# 2499 NORTH MERIDIAN RESIDENCE

2499 NORTH MERIDIAN RESIDENCE - MIAMI BEACH, FLORIDA  
**FINAL SUBMITTAL: NOV DRB** (DRB18-0310) - DESIGN REVIEW BOARD

Staff First Submittal Review Comments Design Review Board

**SUBJECT:** DRB18-0310 | 2499 North Meridian Avenue  
 Comments Issued: 08/31/18 | 08/29/18 JGM IV FSC  
 Final CAP/PAPER Submittal: 1:00 PM on 09/07  
 Notice to Proceed: 09/17/18  
 Tentative Board Meeting Date: 11/06/18

1 PROPOSED GROUND FLOOR PLAN  
SCALE: 3/32" = 1'-0"

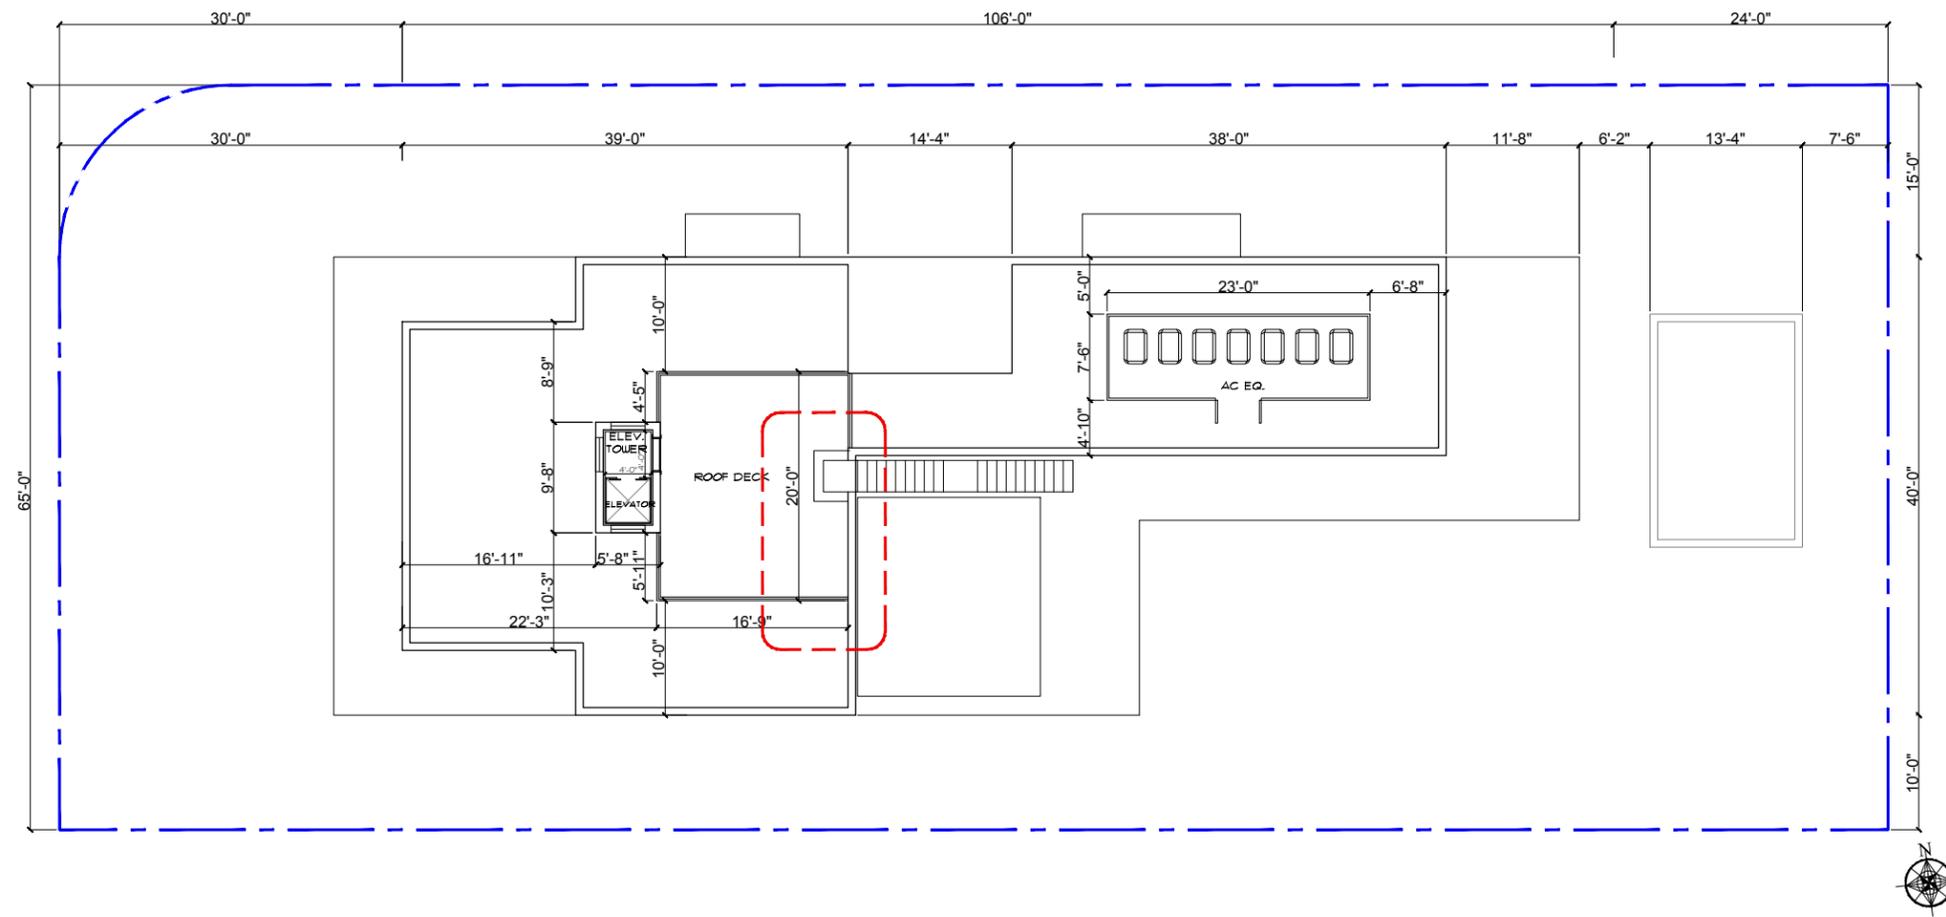
- Cantilevered balcony on the southeast side exceeds 6'-0". Portion exceeding 6'-0" (4'-0") counts in unit size. To be considered as part of a covered terrace, allowed up to 10' in length, the slab shall have supporting elements at the ground floor.  
A/: column supporting slab for covered terrace added on the southeast point. Please see ground floor plan in sheet A2.1

SHEET NO:  
**A2.2**

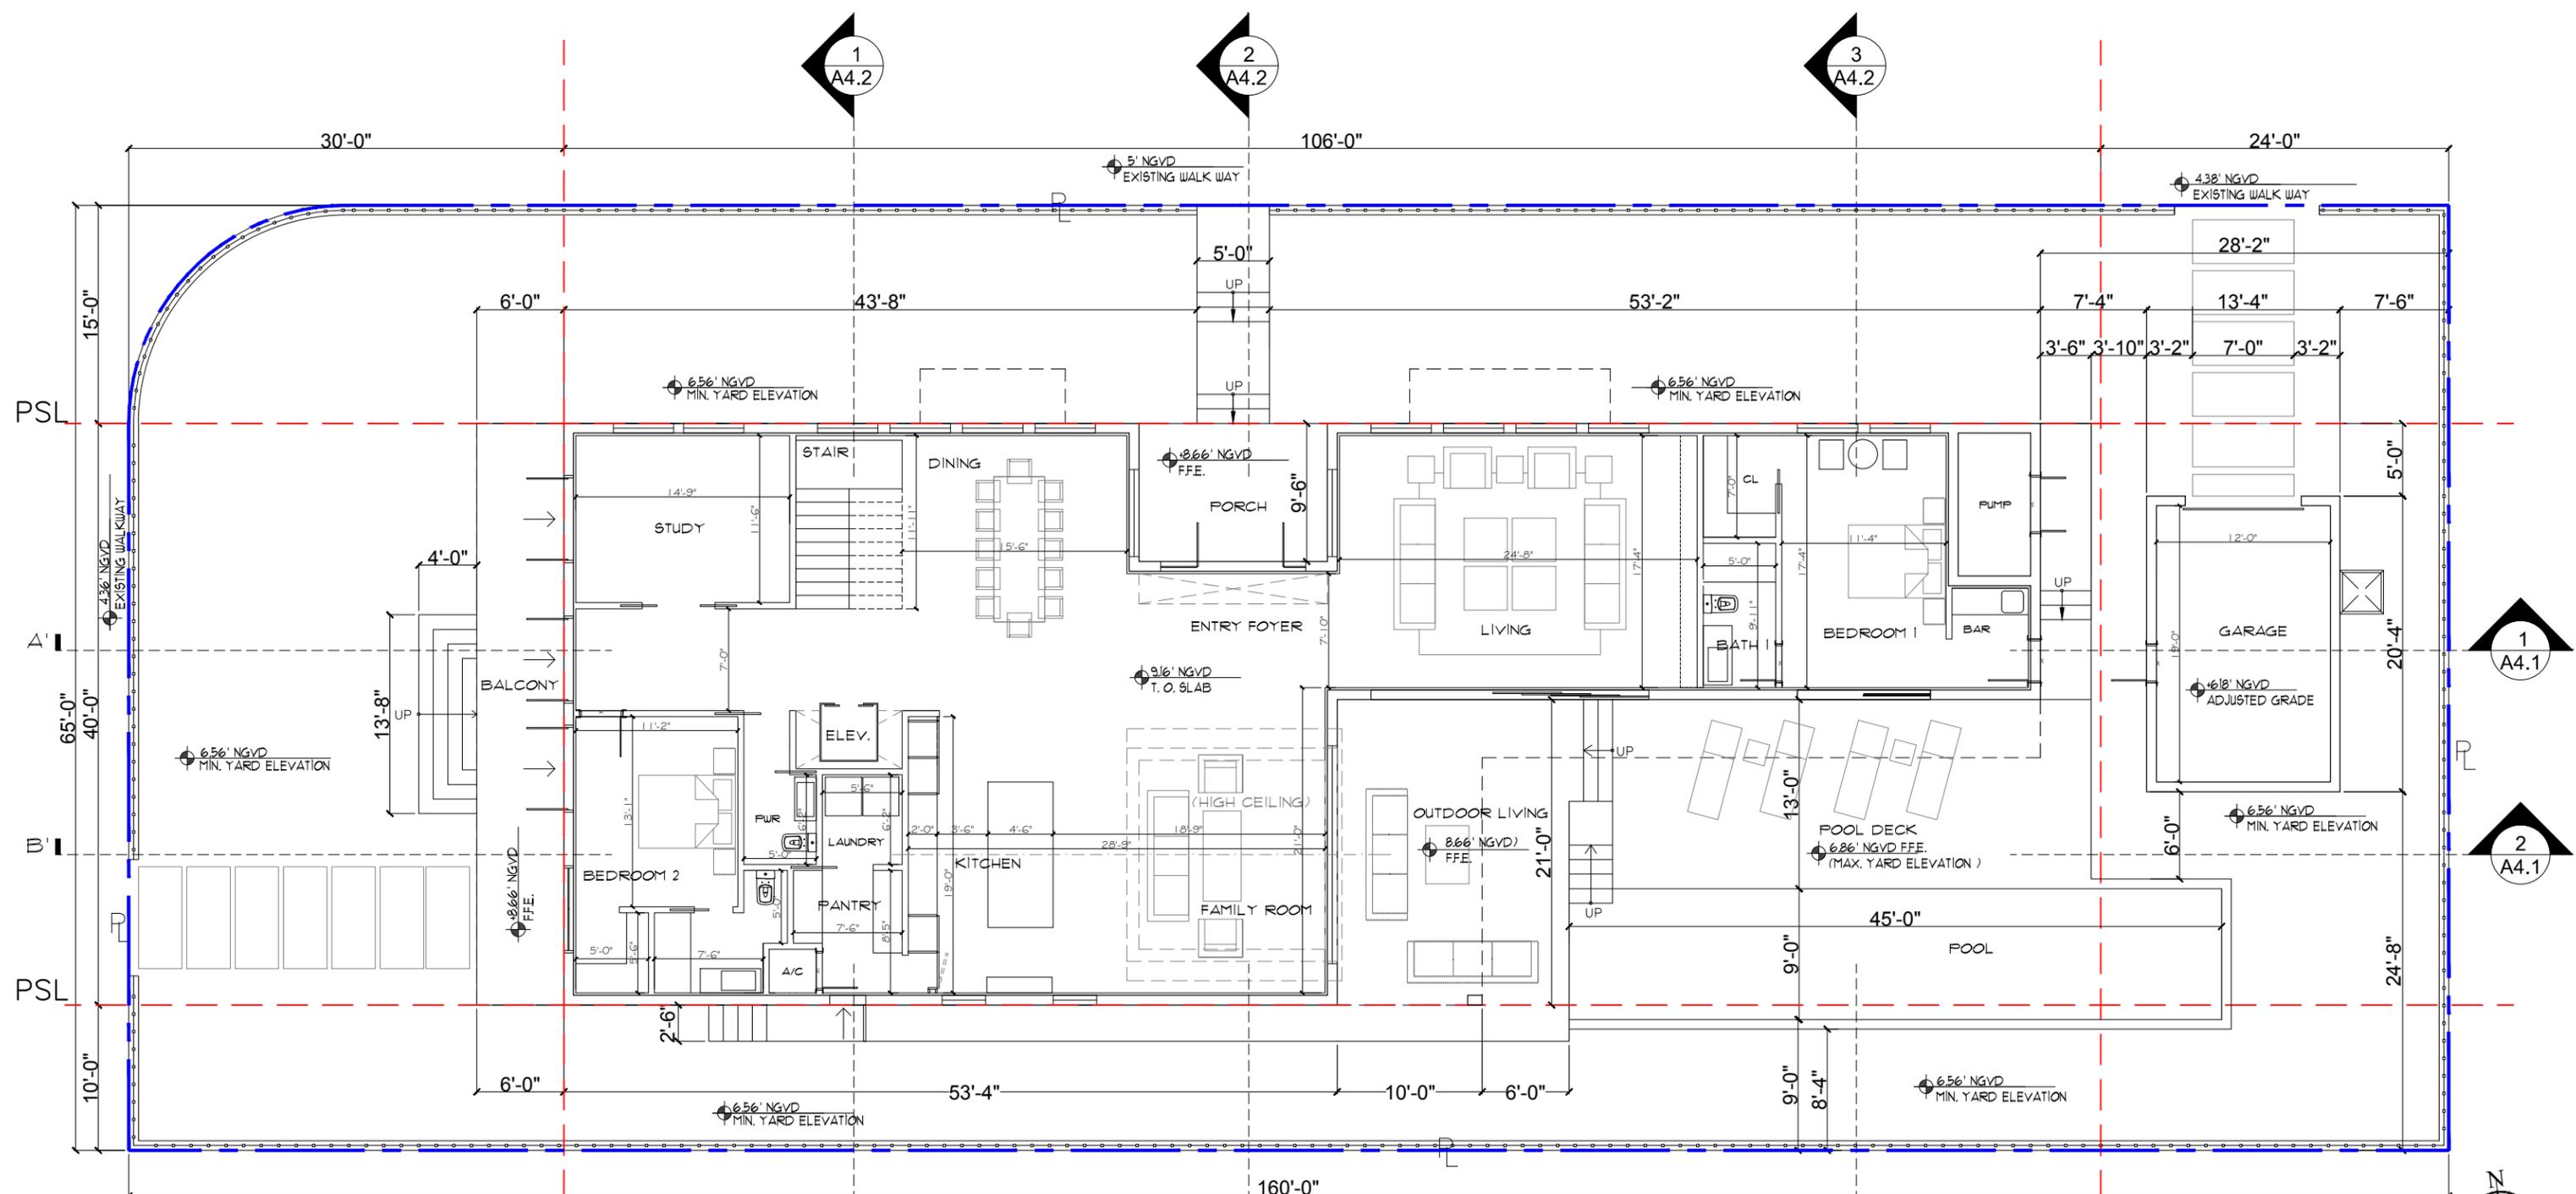
- Revise title of drawing on page A2.2 to be second floor plan.  
A/: Title of drawing revised, please see sheet A2.2

1 PROPOSED SECTION C  
SCALE: 1/8" = 1'-0"

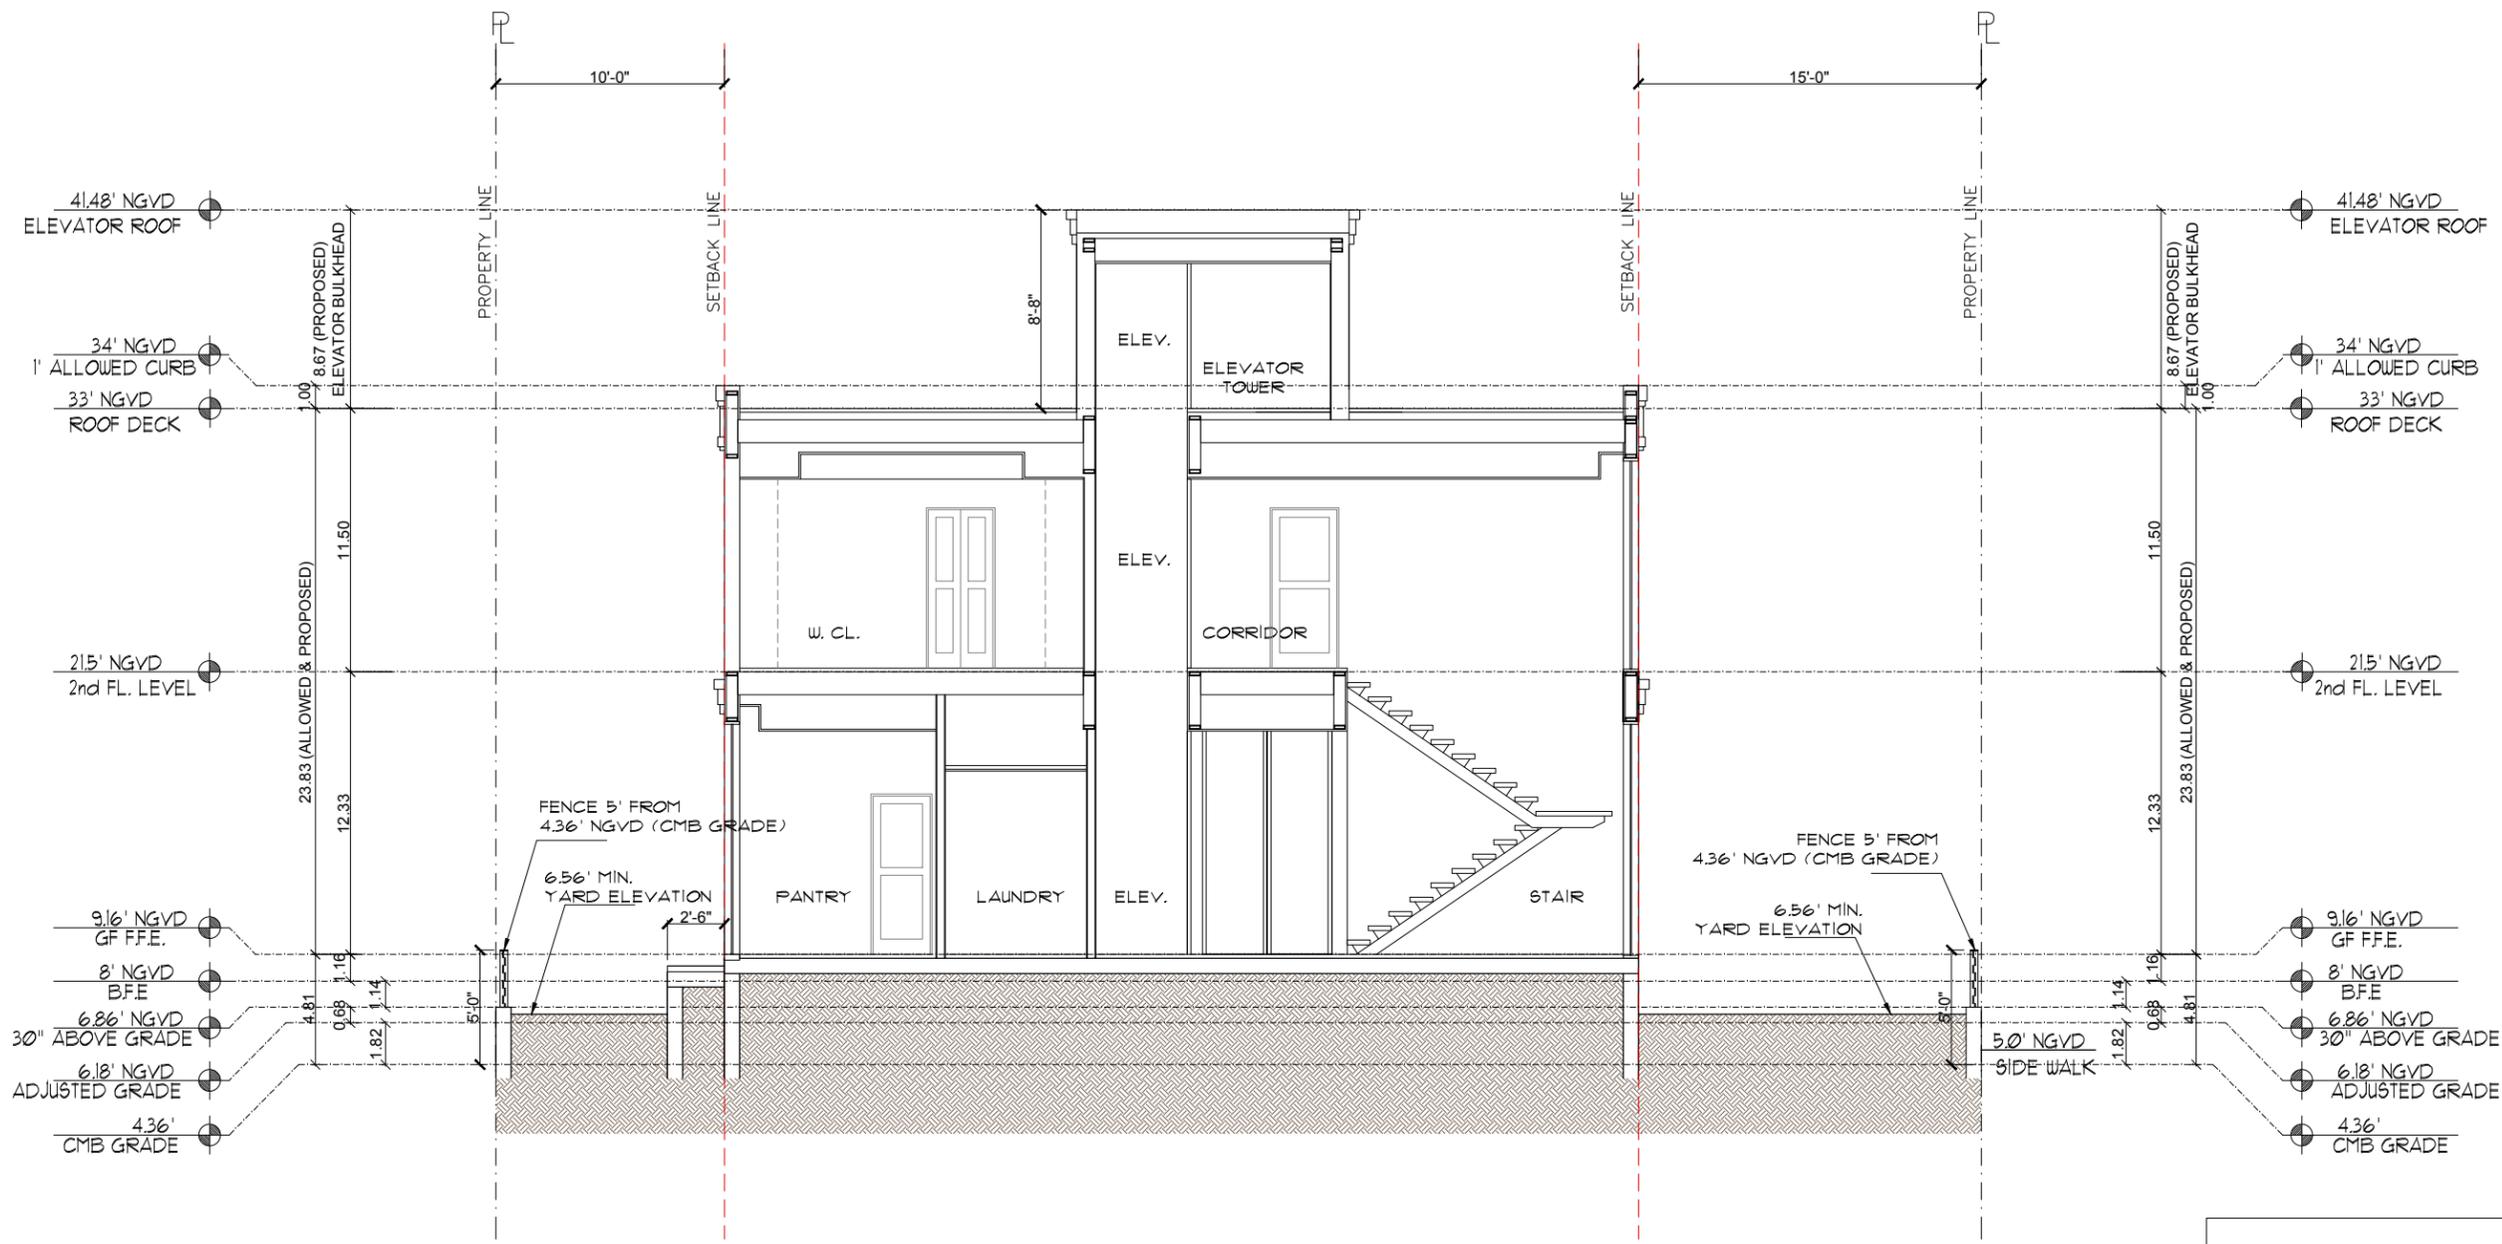
- Fence height is measured from grade elevation (elevation of the sidewalk at the center of the property). Plans indicate grade and elevation of the sidewalk shall be the same number. See section c, page A4.2.  
A/: Fence in all elevations and sections revised to 5' from grade. Grade is 4.36' NGVD as per survey elevation datum on the walkway on Meridian Ave.
